Fast link recovery proposal

11/18/2009

Gavin Parnaby

Add refresh monitor state diagram

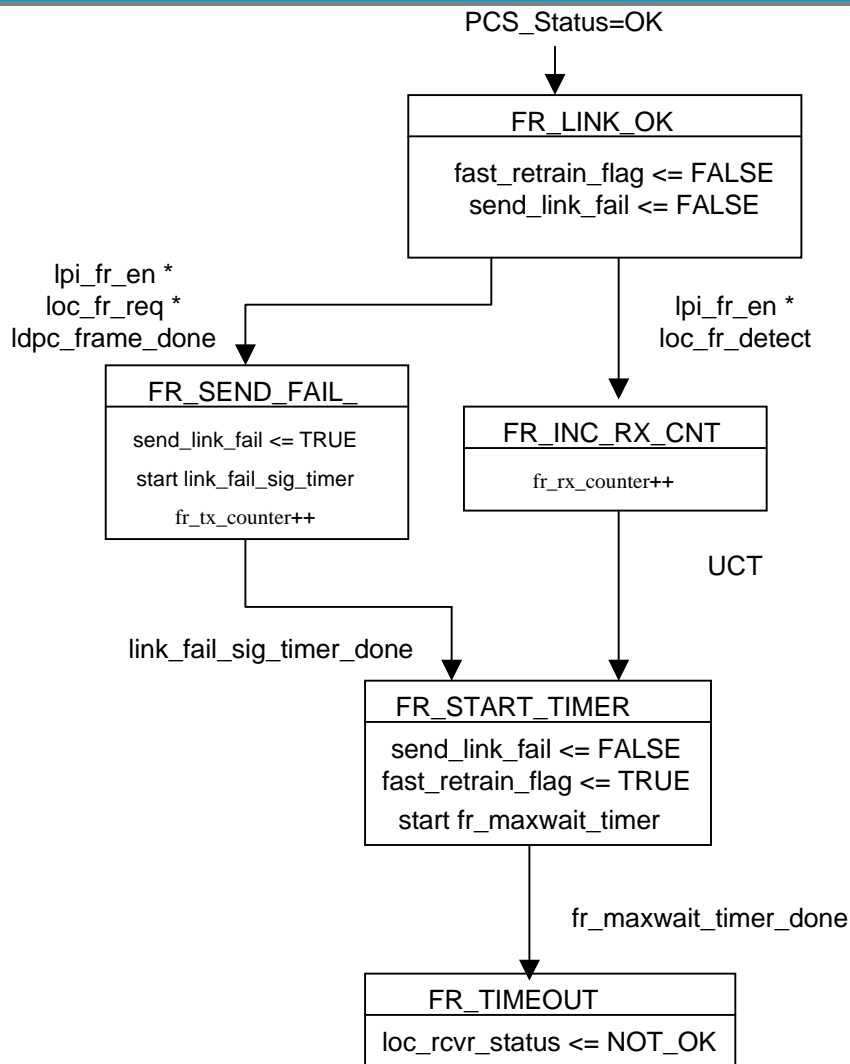
- Add variable `lpi_refresh_detect`
 - Set **TRUE** when the receiver has reliably detected a refresh signal. The exact criteria left to the implementer.
- Add timer `lpi_refresh_rx_timer`
 - Period of TBD us (330us?)
 - 330us <-> 2 complete qr cycles
- Add variable `lpi_fr_en`
 - When **TRUE** the fast retrain capability is enabled. The variable is set through a management register.
- `LPI_REFRESH_TIMEOUT_FR` and `LPI_REFRESH_TIMEOUT` both force a link retrain (fast / normal respectively)

Figure 55-24—PHY Control state diagram

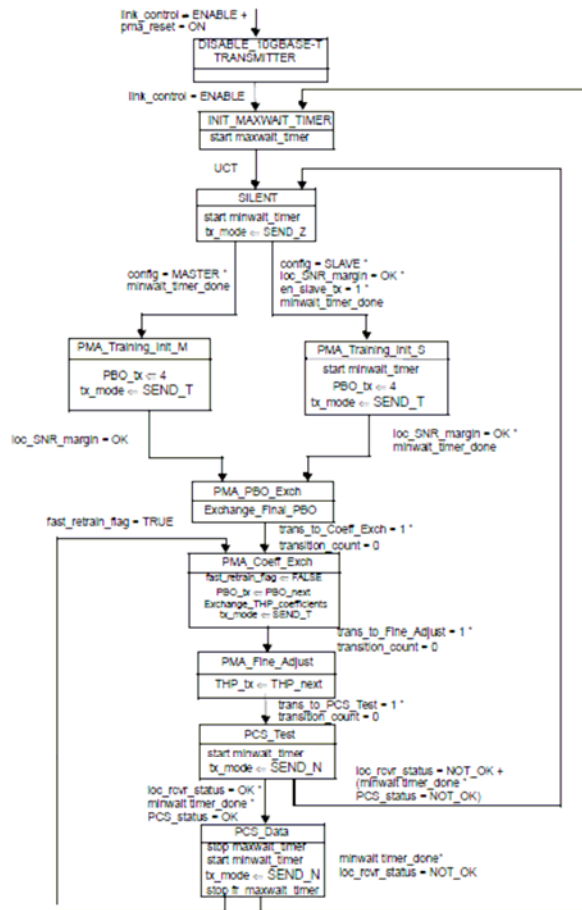
Fast retrain changes to Fig 55-24

- Re-enter at PMA_Coeff_Exch
- PAM2 signaling eliminates slicer errors
- Robust training
- Reuse existing states and transition protocols
- Minimize new text

Figure 55-25—MASTER transition counter state diagram

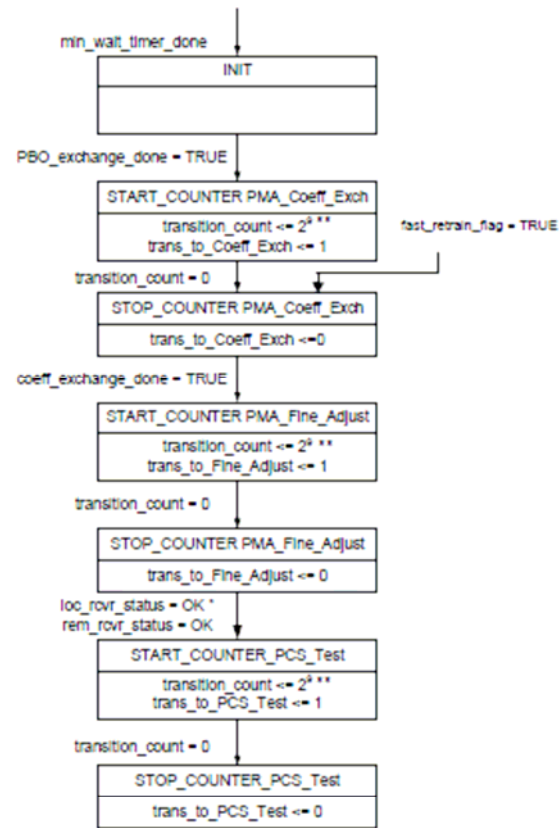
Figure 55-25 changes

** - devices supporting fast retrain use 2⁵

Figure 55-26—SLAVE transition counter state diagram

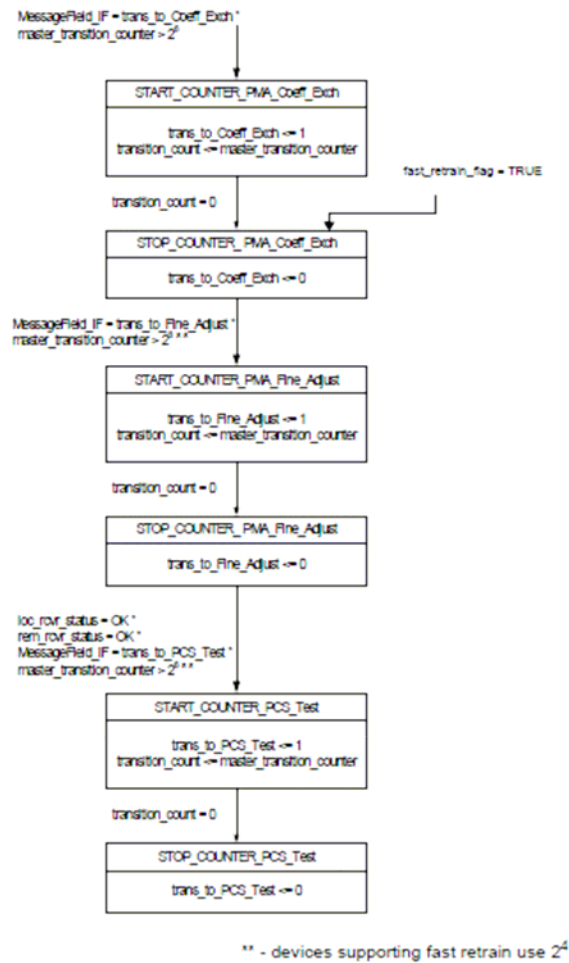
Figure 55-26 changes
